**ANGEL PLACE  
LEVEL 8, 123 PITT STREET  
SYDNEY NSW 2000**

## **SECTION 4.55(1A) - MODIFICATION OF SSD-10437 - WATERLOO METRO QUARTER OSD SOUTHERN PRECINCT DETAILED DESIGN SSDA**

This letter has been prepared by Urbis on behalf of WL Developer Pty Ltd with regards to a Section 4.55(1A) application to modify State Significant Development (SSD) Waterloo Metro Quarter Over Station Development (OSD) Southern Precinct Detailed Design SSD-10437.

Figure 3 Approved and Proposed Building 3 Roof Plant Plan

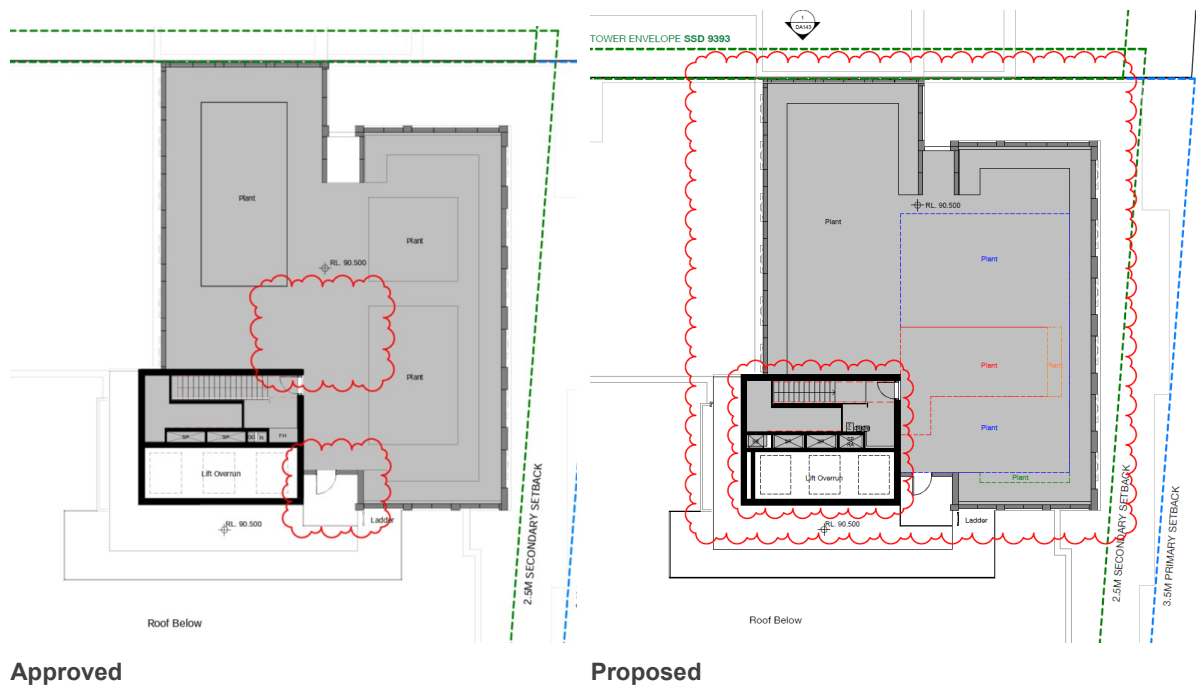
Revised rooftop plant zones – Increase height of plant zones to maximum RL93.95, which is at the same height as the maximum height of the approved building, and does not exceed the approved Concept building envelope maximum height (Concept SSD 9393), which is RL 96.9 (see Figure 3 and Figure 4).

Figure 5 Indicative views from the various location of the public domain

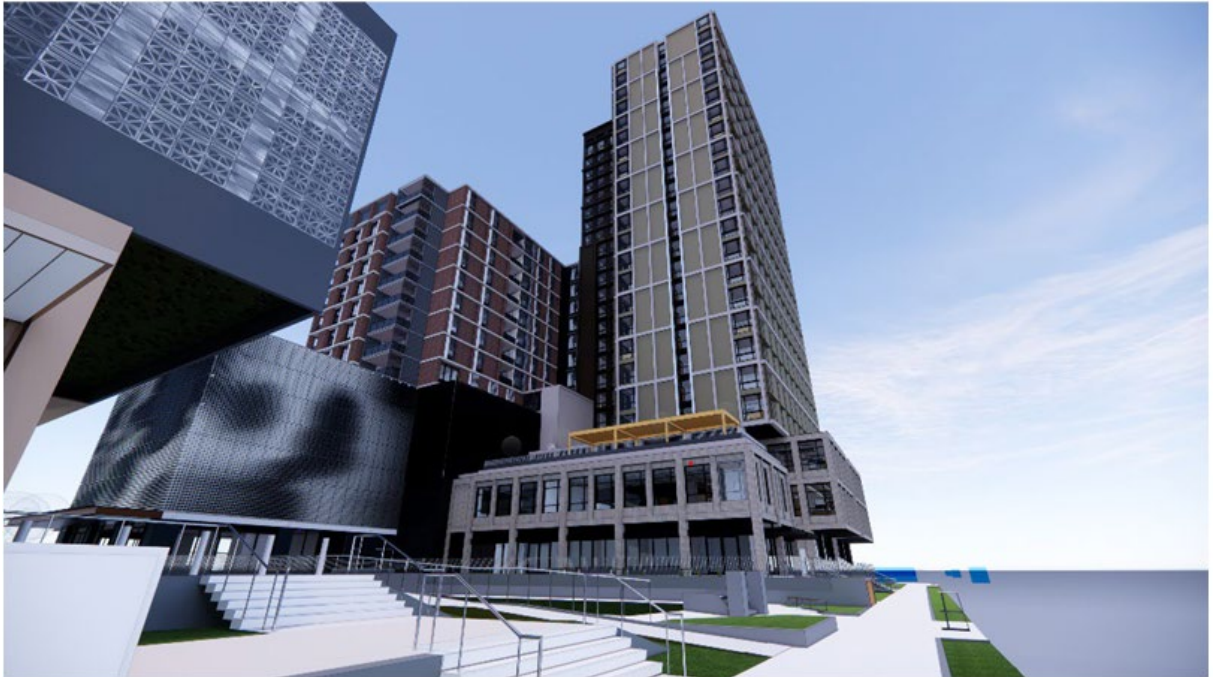
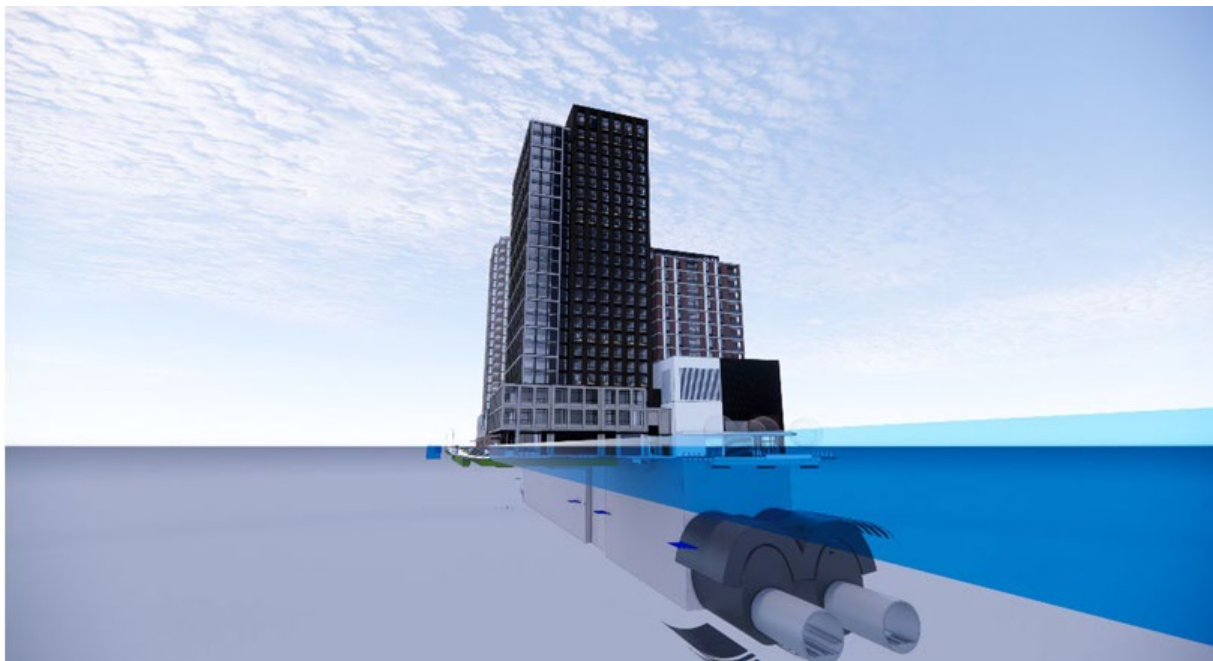
- Setback from the building edge to reduce visibility, and
- The plant zones are predominantly below the approved maximum height of the building. One plant zone is at the same height as the maximum height of the approved building (at RL 93.95).

As per Figure 5, the proposed plant zones are not visible from

- From the corner of Botany Road and Wellington Street looking north.
- View from Botany Road adjacent to Building 2 looking south.
- View from Botany Road - approximately 80m from the south western corner of Building 3.

Figure 6 View comparison from the corner of Botany Road and John Street (looking north)

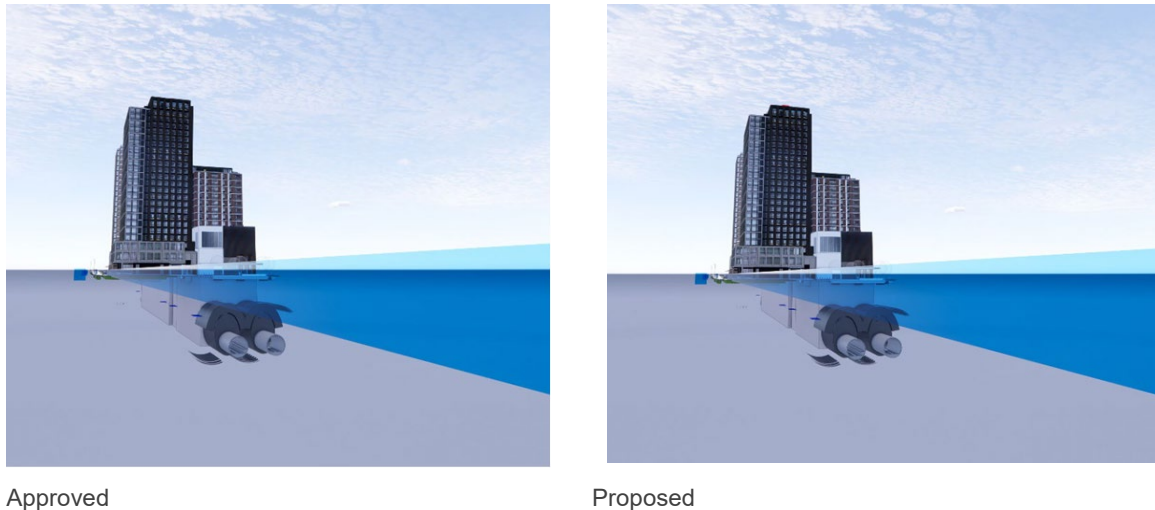
When viewed from the corner of Botany Road and John Street (looking north), approximately 160m from the south western corner of Building 3, the tallest rooftop plant zone (at RL 93.95) is slightly

visible from the public domain. However the visual impact is considered to be minimal when compared to the approved, and the top portion of the plant zone is hardly perceivable (refer to Figure 6).
